**TOWN OF BROOKLYN
PLANNING AND ZONING COMMISSION
Regular Meeting Agenda
Wednesday, July 7, 2021 6:30 p.m.**

ENGINEERING PLAN REVIEW PERTAINING TO A 3-LOT SUBDIVISION (ASSESSOR'S MAP 41, LOT 85) PROULX STREET BROOKLYN, CT (April 30, 2021)

ENGINEERING PLAN REVIEW PERTAINING TO A 4-LOT SUBDIVISION CNG HOLDINGS, LLC (ASSESSOR'S MAP 42, LOT No. 32) DAY STREET BROOKLYN, CT (May 7, 2021)

TRENCH DETAIL: SANITARY SEWER SERVICE

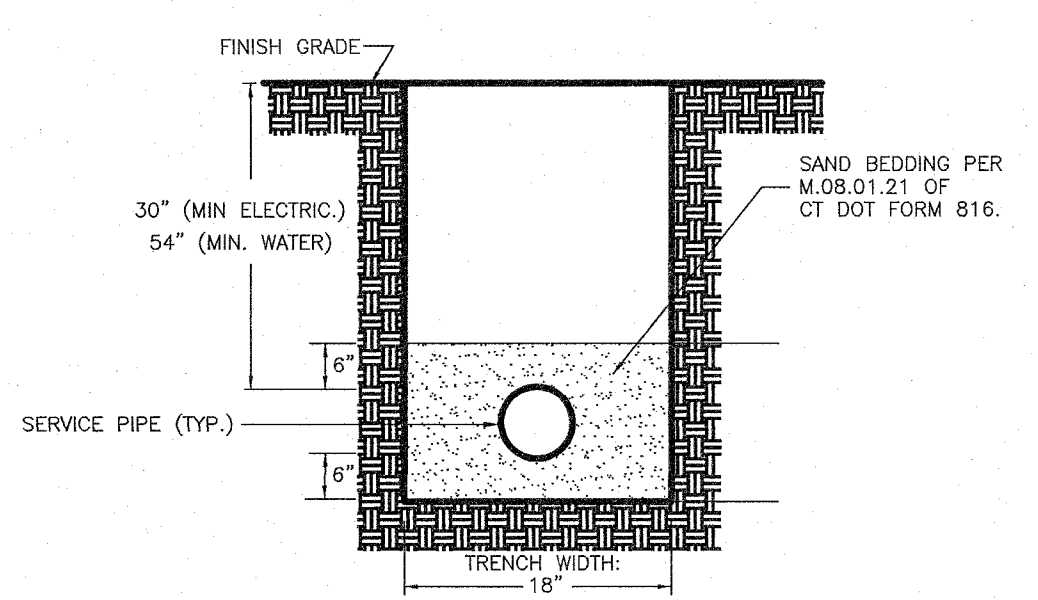
3. Any reference to the CT DOT Form 816 shall be changed to the current Form 818.
4. The "Trench Detail: Sanitary Sewer" and "Typical Service Pipe Trench Detail" need to show detectable warning tape over conduits that are manufactured from non-ferrous material.

Site Analysis Plan
"2 Lot Subdivision"

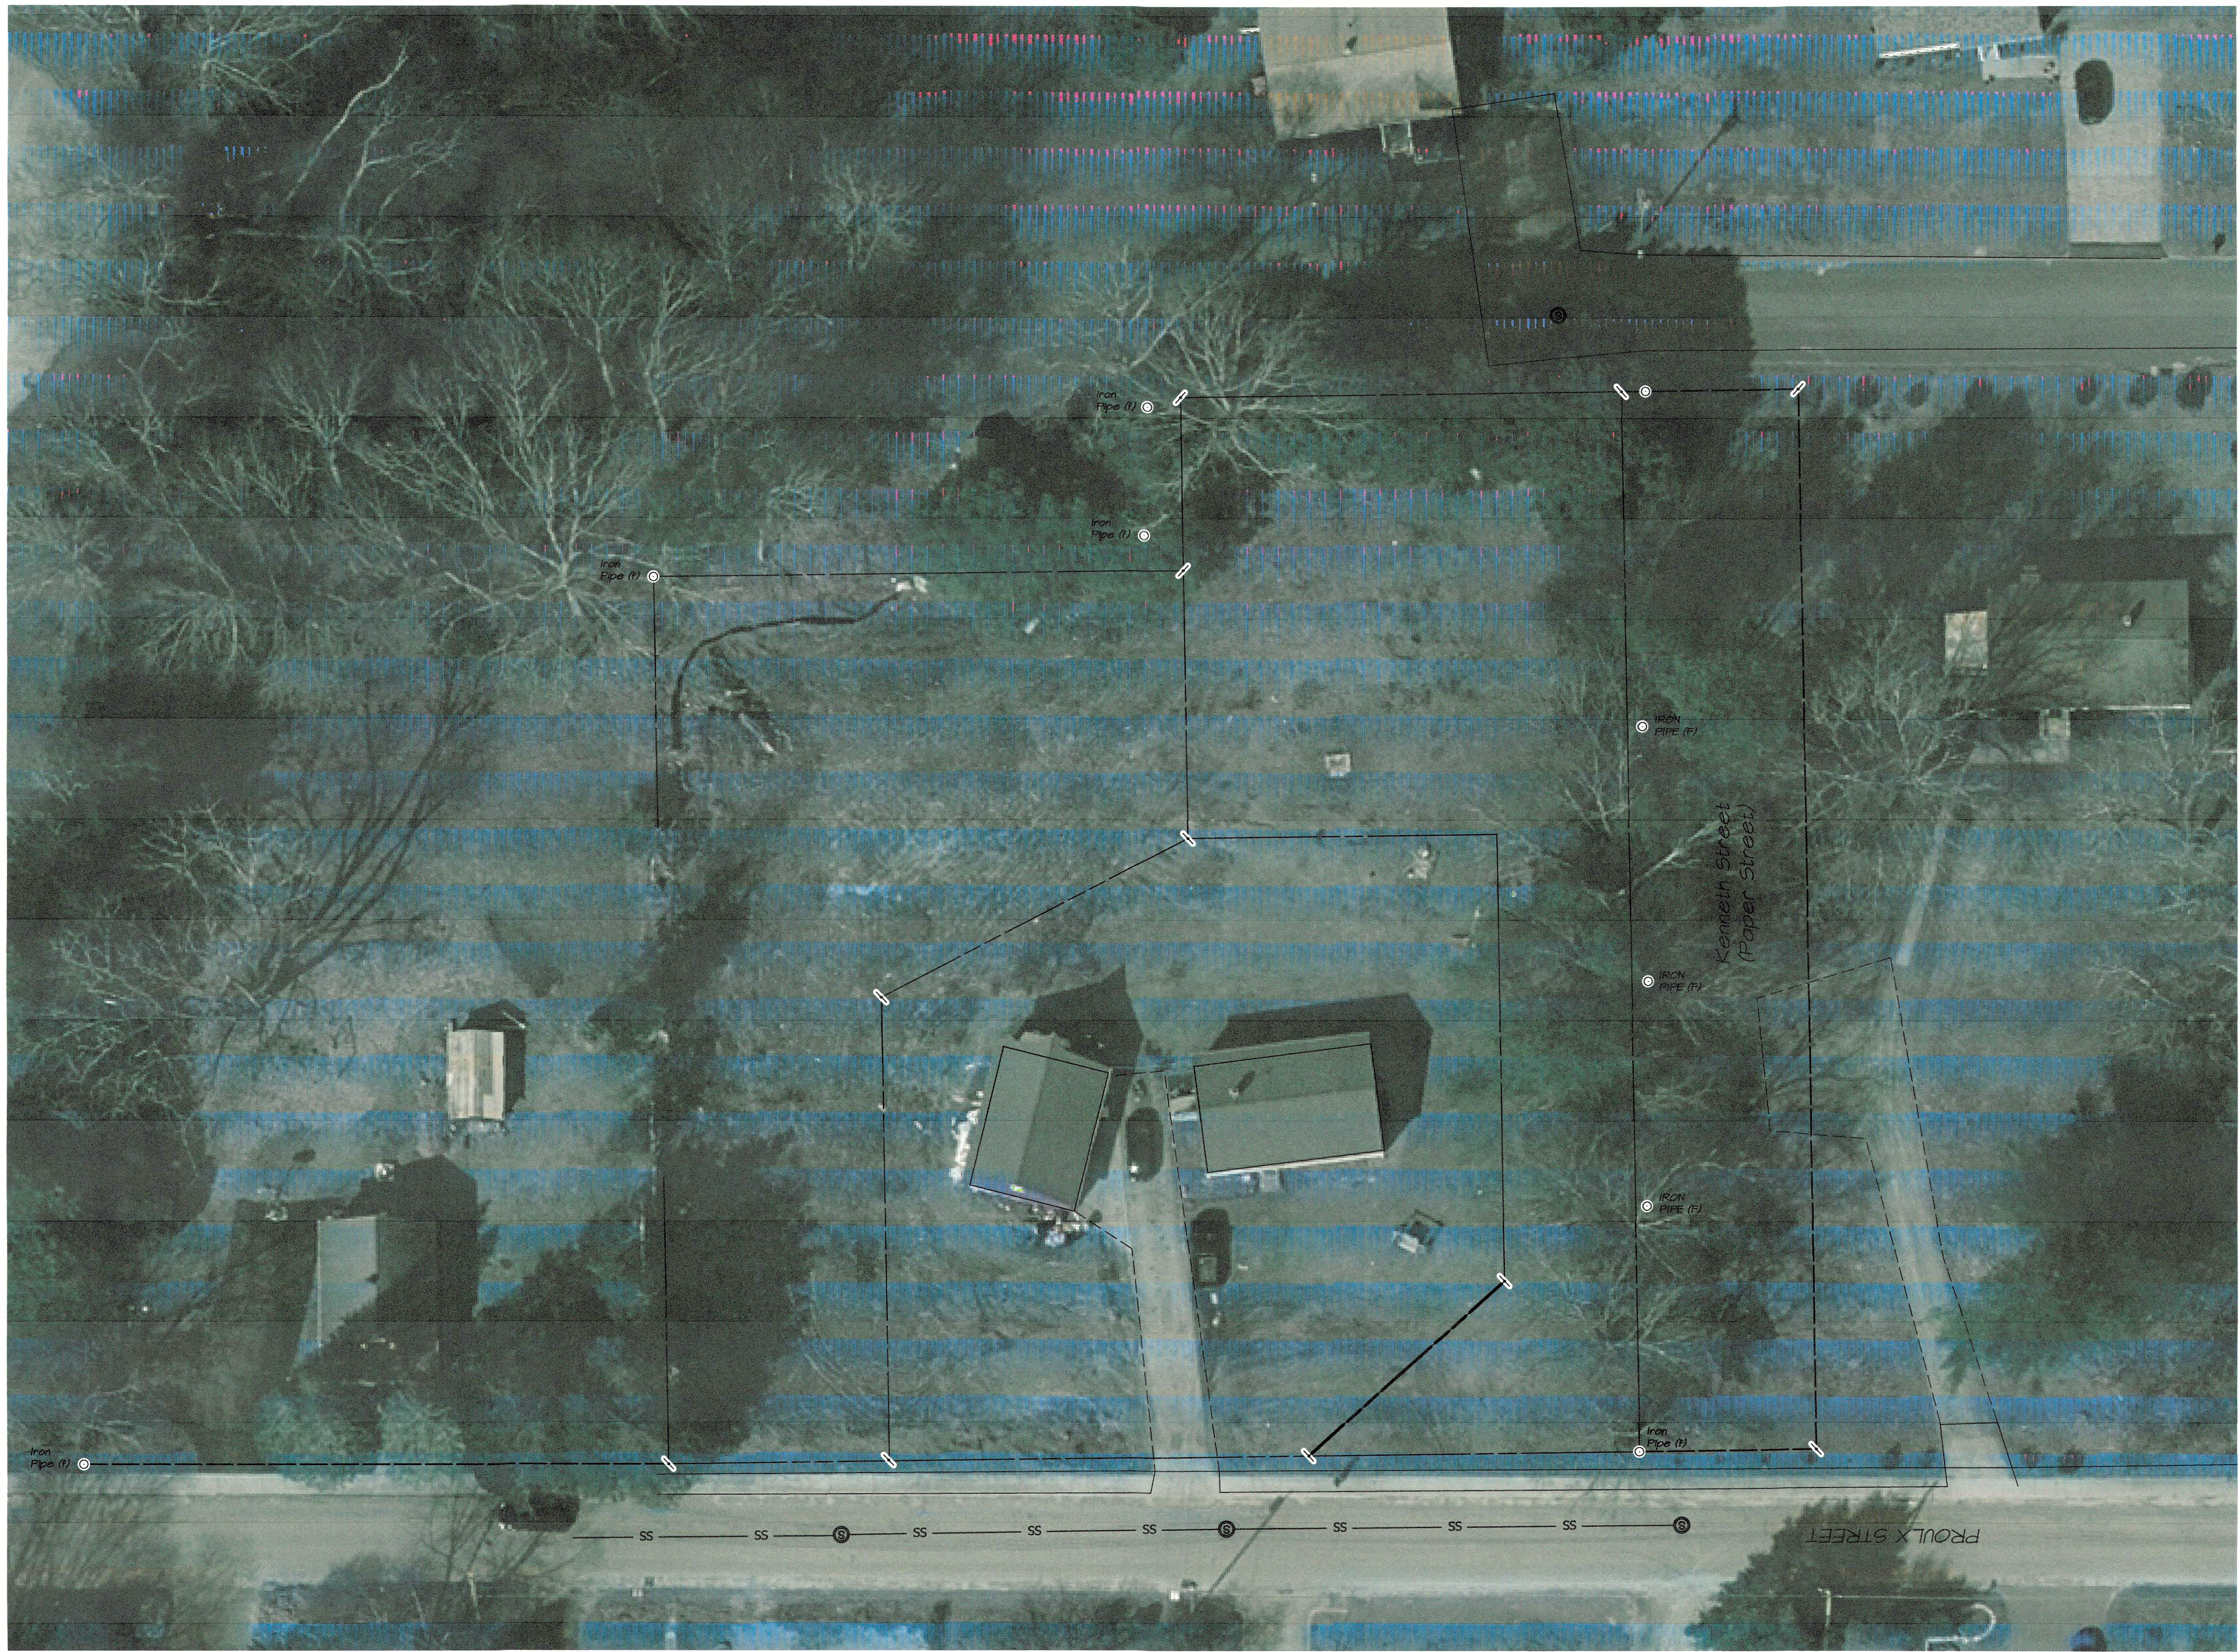
1. Proposed Lot 85-1 abuts Robert Street, a public street, which indicates that west property line is "frontage" on a public street and not a "rear" lot line. The plan indicates that the setback distance is a "rear setback" at 15' rather than a "front setback" of 35'. This discrepancy needs clarification and if in fact the "rear" line is a "front" line, the house footprint (with deck) must be moved to the east out of the setback area.

6. The side slopes in the "Typical Driveway Cross Section" are shown to be 2:1 and must be changed to 3:1.
7. No reference whatsoever is made as to the accuracy of the topographic elevation portion of the survey. This is of a concern because field observations seem to indicate steeper elevation changes from the Proulx Street edge of pavement into the property (estimated to be 4'-6' below grade) and no surface mounding (see elevation 226 on the plan) was observed adjacent to the southeast corner of Lot 85 as indicated on the plan. This inconsistency needs explaining.

8. Due to the steep change in grade from the shoulder of Proulx Street into the property, the "Residential Driveway Section Details" from the Brooklyn Public Improvement Specifications need to be included in the plan set. Also, provision shall be made for surface water drainage from up-gradient properties to be able to pass freely under any portion of land that is filled to accommodate a driveway to meet the public improvement specifications if the land shall be so impacted so as not to cause ponding.

9. Paved driveway aprons per the "Brooklyn Public Improvement Specifications" are not shown on the plan.
10. The building sewer line to the main in Proulx Street is called out as having a 1% slope (gravity). Considering the proposed first floor elevations and approximate sewer main elevations in the street, it appears that the building sewers at both proposed houses would be exiting the house foundation about 24" below the first floor for each house. Is that practical, considering that residents with such an arrangement would find that arrangement awkward if these houses are built with a full basement and they chose to place water using appliances in their cellar that require a discharge line?

11. Was any consideration given to connecting to the sanitary sewer line in Robert Street?
12. Why isn't the mound (Elev. 226) near the north east corner of the proposed house on Lot 85-2 being eliminated instead of being enlarged as shown on the plan? This needs to be eliminated to improve surface water runoff across the lot and lessen the impact to the house. In the field this looks like nothing more than a pile of accumulated debris.

14. The proposed fill slope opposite the middle of the house footprint on Lot 85-1 needs to reflect a 3:1 (max) slope. As drawn, is a 2:1 slope.
15. Why are so many of the old iron pipe property markers found so far off the Archer Surveying , LLC property lines shown on this plan?

17. No test pit information is included with the plan to determine the presence of any groundwater, seasonal high groundwater (mottling) or ledge. Test pits need to be dug due to the close proximity of the wetlands to the rear of the property and the puddles that were observed during the site visits.
18. Additional wetland delineation is needed to the north of WF#1 in order to better define the 125 wetland review area for proposed Lot 85-2.
19. The soil scientist's signature block is missing on this plan certifying the wetland flag line.

Existing Condition Plan

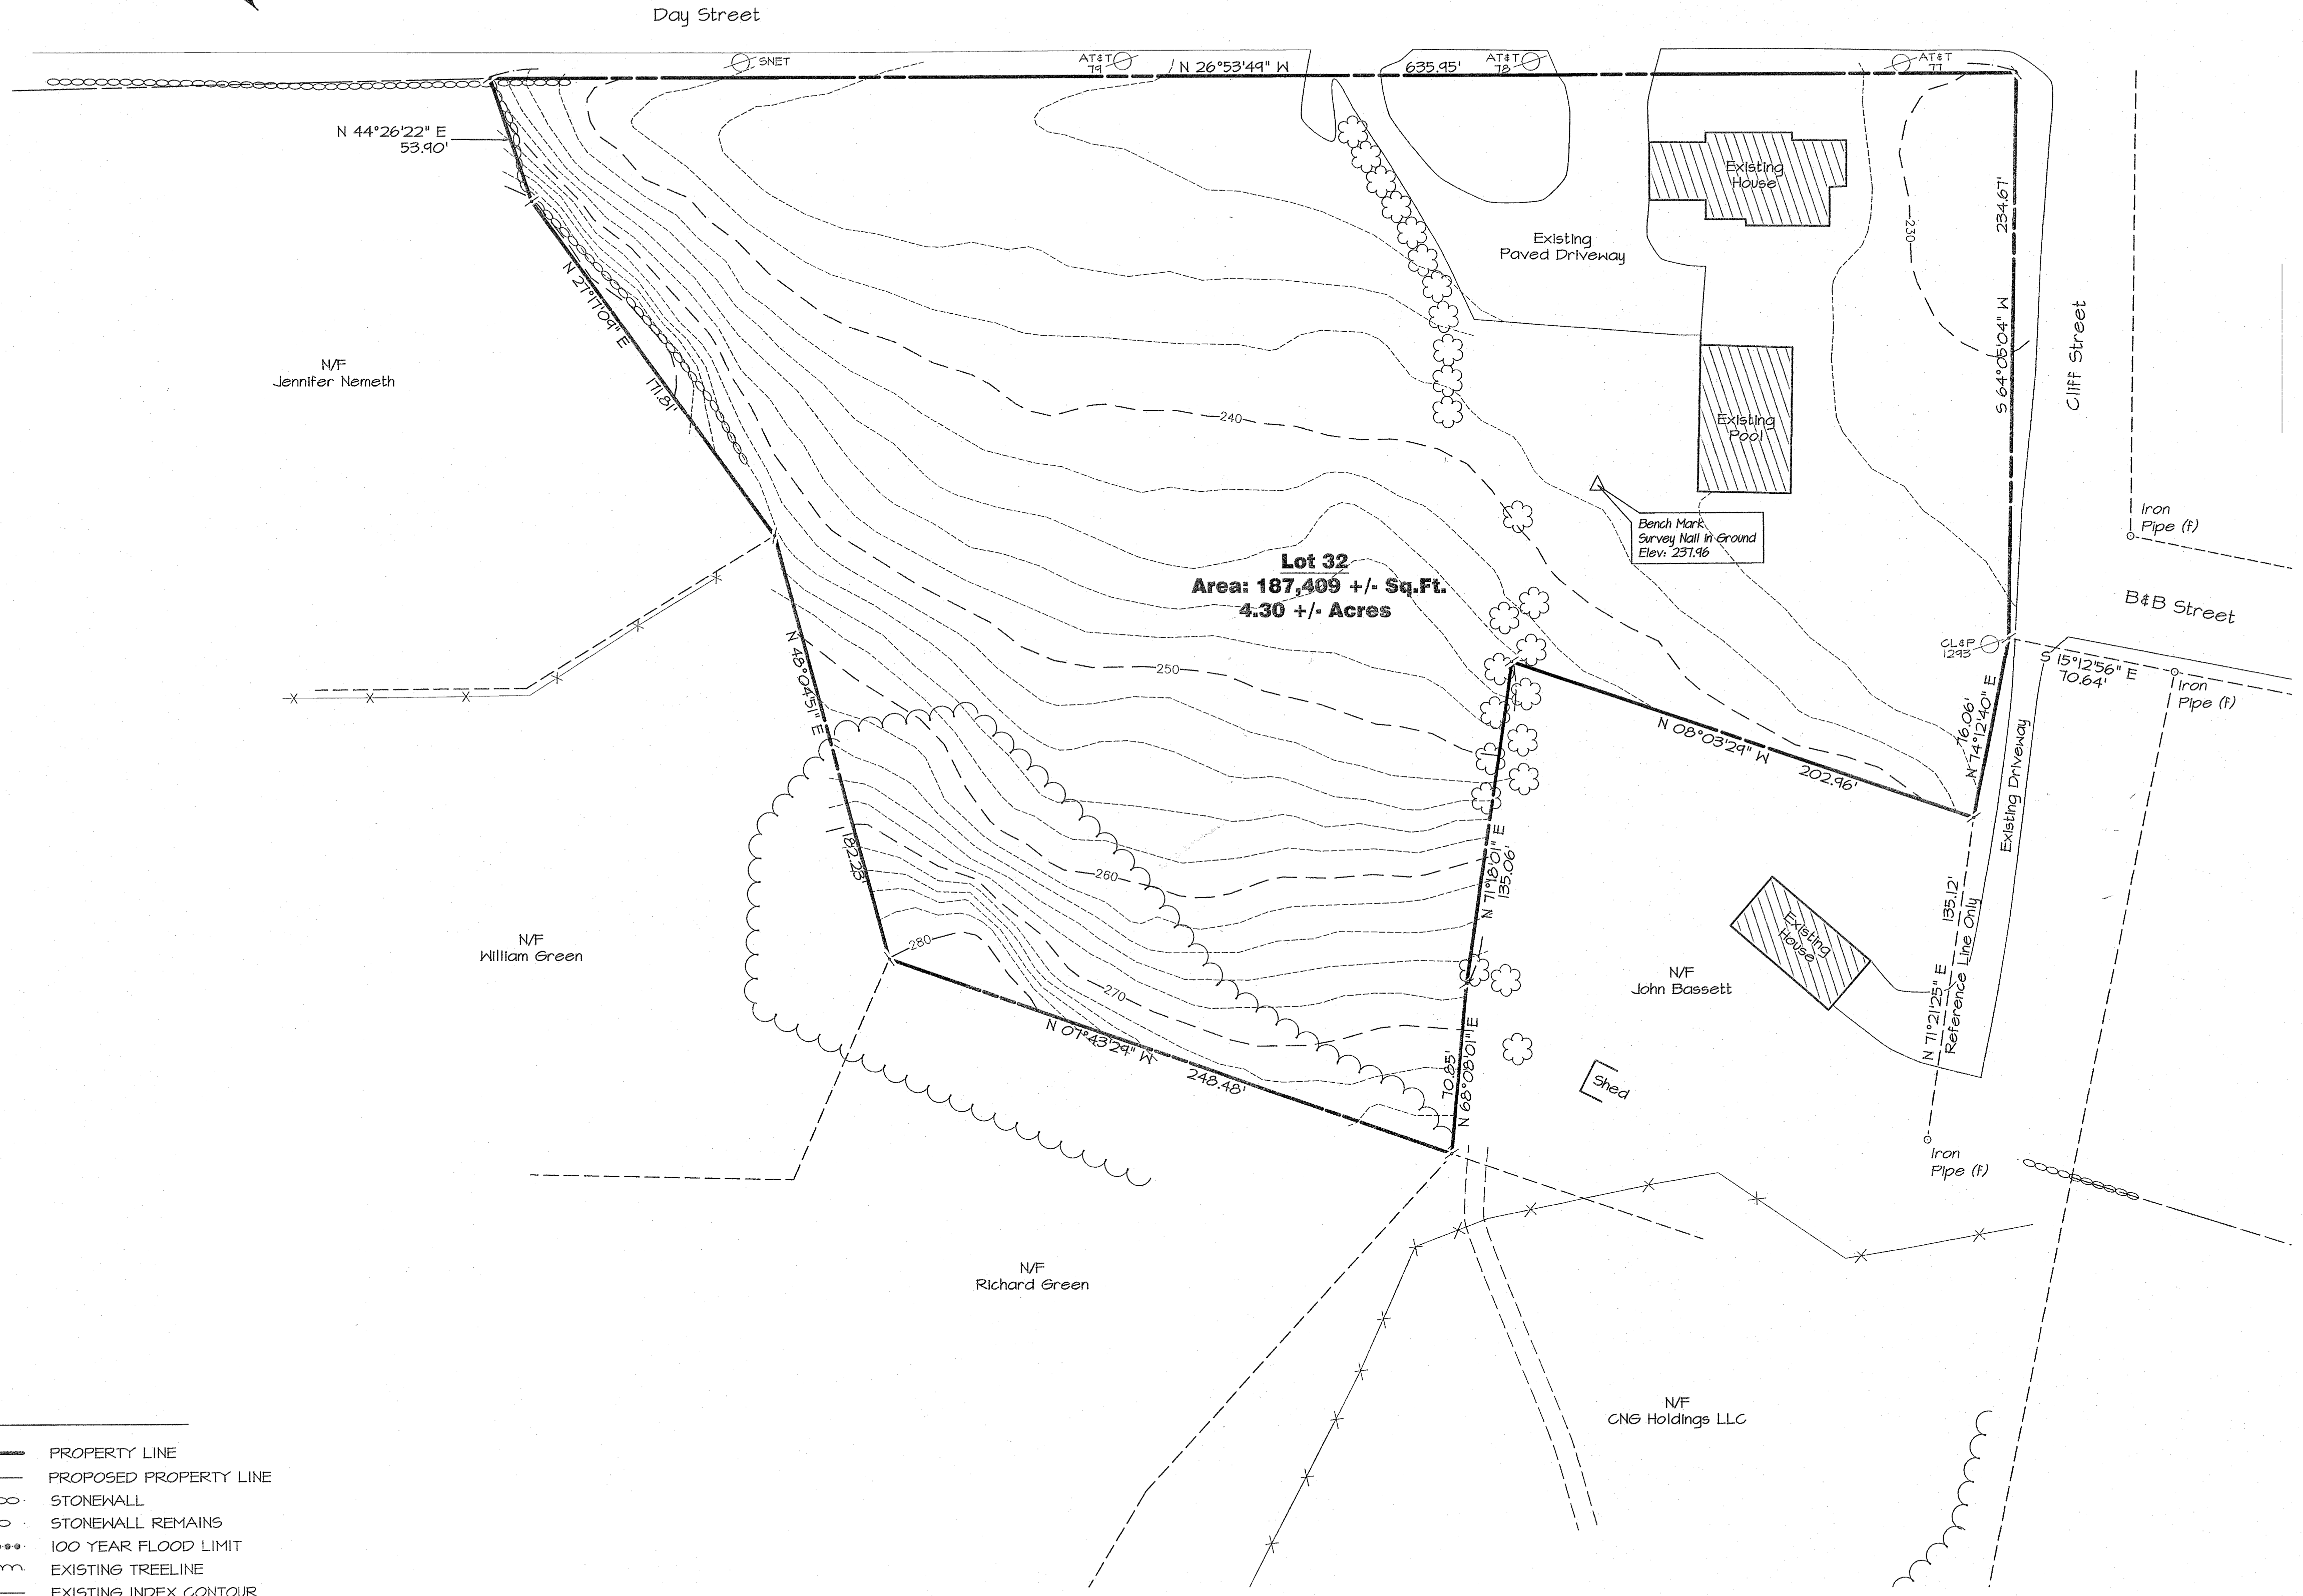
1. Location Map is missing a north arrow.
2. Note 1 under “Notes” does not include the accuracy of the topographic elevations shown on the plan. The accuracy needs to be included as part of this note.
3. A silt fence, compost/silt sock and/or hay bale sediment control symbol needs to be included in the “Legend.”
